## Questions from the October 26, 2022, Email

### **Additional Questions from the November 3, 2022, Teleconference**

**Figure 9-4 Turbine Building Geoprobe Soil Scanning Locations**

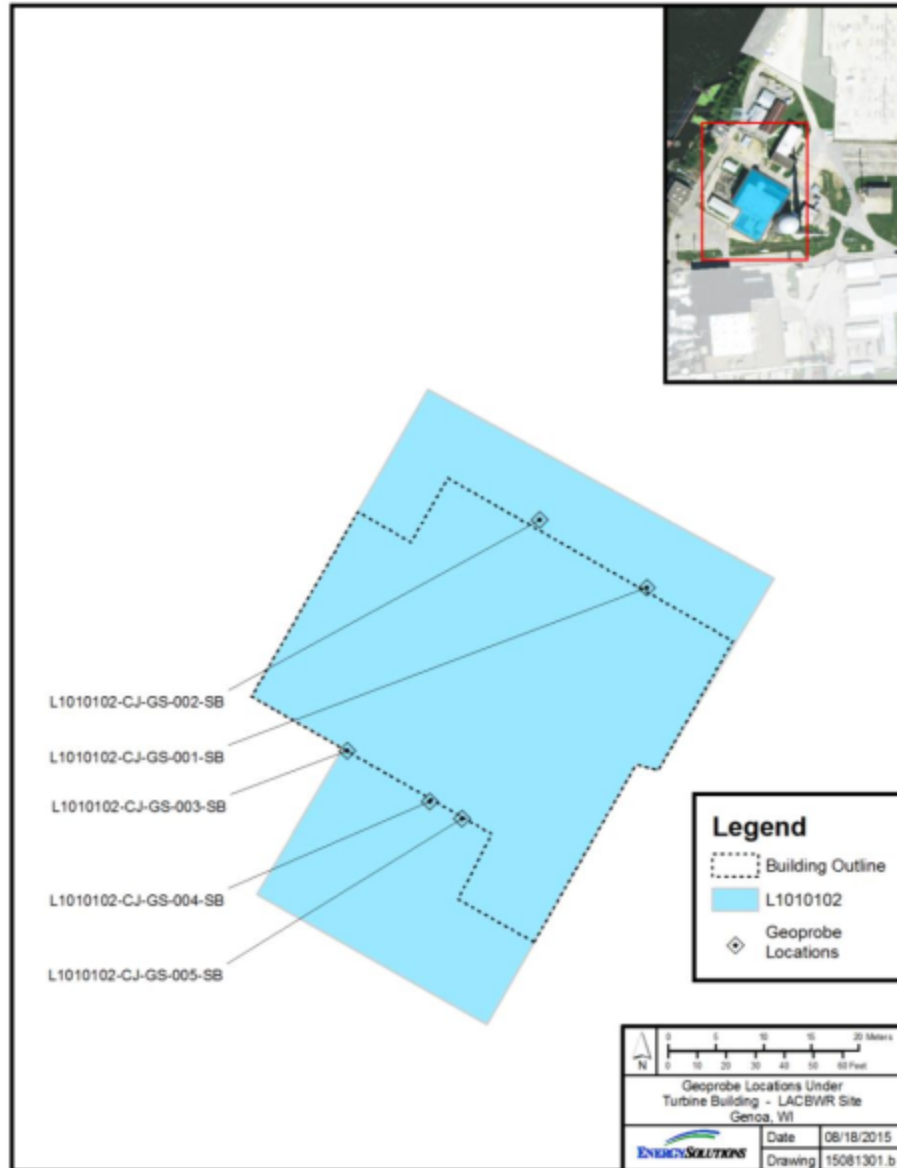
3. Explanation on soil disturbance in sump area of TDS-B.

*Contamination found outside the of the sump area was a result of excavation of soil spreading contamination in the immediate vicinity of the RPGPA sump.*

*Subsurface characterization of the areas around and beneath the Turbine Building show that there was no significant surface or subsurface soil contamination. Table 9-4 of the Characterization Survey Report for 2014 (GG-EO-313196-RS-RP-001, Revision 0), below, shows the results of the subsurface soil analysis performed in survey unit L1-010-102, which were to a maximum depth of 4 meters.*

The figure below (Figure 9-4 of LC-RS-PN-164017-001) shows the locations of the soil samples depicted in the above table.

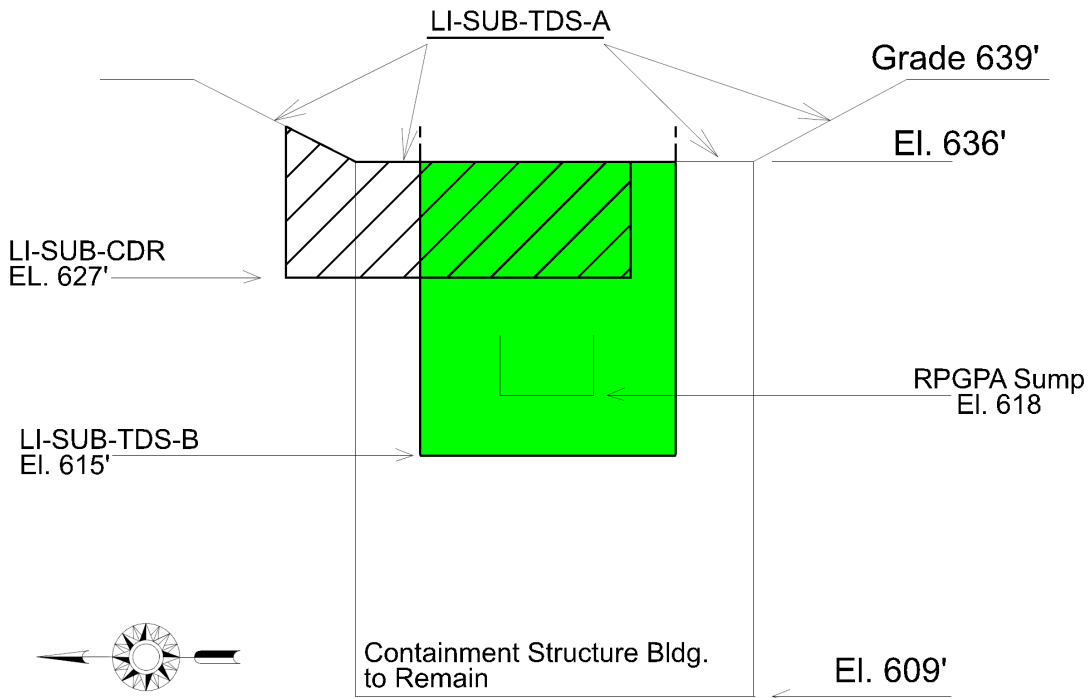
5. CDR, TDS-A, and TDS-B survey and backfill timeline.

*Excavation and demolition of the Pipe Tunnel/RPGPA (L1-SUB-CDR) was completed in August to September 2017. L1-SUB-CDR was excavated to approximate elevation 627' and L1-SUB-TDS-B was excavated to approximate elevation 618'. Backfill of the area was*

completed between 09/20/2017 and 09/26/2017, except for the RPGPA/Sump area (L1-SUB-TDS-B) which was backfilled 04/18/2019. L1-SUB-CDR was backfilled to approximate elevation 629', and L1-SUB-TDS-B was backfilled to approximate elevation 636'.

## North-Facing Layout of CDR, TDS-A, and TDS-B Excavations

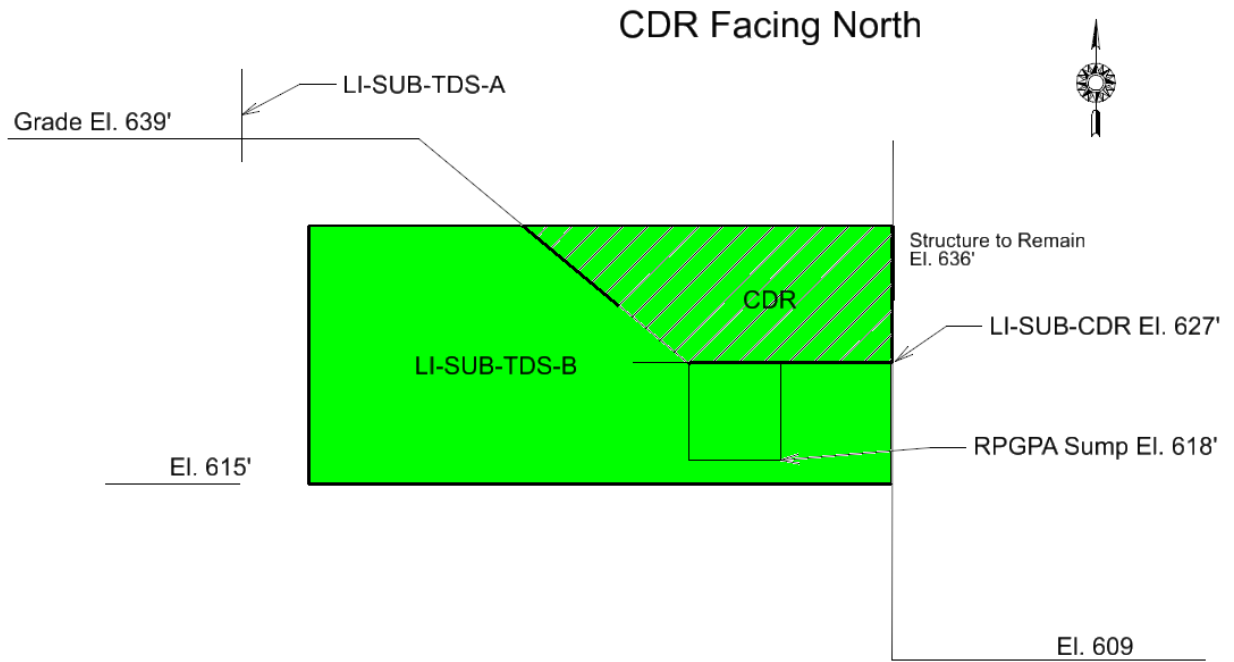
6. We are still trying to piece together the various elevations and survey unit overlap. At what elevation was the CDR soil at the time of the CDR FSS? It is our understanding that the bottom of the trench box was at the 618’ elevation, but the team does not know the elevation of the soil outside of the trench box that was still within the footprint of the RPGPA survey unit. Some of this area is the sloped walls to the trench box, but what was the elevation of the top of the sloped walls? How does that elevation compare to the rest of the CDR survey unit? Also, is the RPGPA survey unit boundary at the top of the sloped wall?

Portions of L1-SUB-TDS-A consisted of sloping to enable FSS Technicians to access L1-SUB-TDS-B. L1-SUB-TDS-A never reached the extent of where L1-SUB-CDR was excavated to. In the vicinity of L1-SUB-CDR and L1-SUB-TDS-B, the elevation of L1-SUB-TDS-A ranged from approximate elevations 639' to 632'. The FSS of L1-SUB-TDS-A was performed 06/26/2019 through 07/12/2019. L1-SUB-TDS-A is at different elevations than L1-SUB-TDS-B, the majority of which is higher than L1-SUB-TDS-B.

As explained above, no excavation affected the final surface (subject to FSS) of another excavation. These survey units overlap in some areas on the (x,y) axis, but when taking into account the depth (z) of each excavation, the surfaces subjected to FSS do not interact. All isolation and control measures were adhered to, the main mechanism being the use of backfill, to ensure survey results were not compromised.
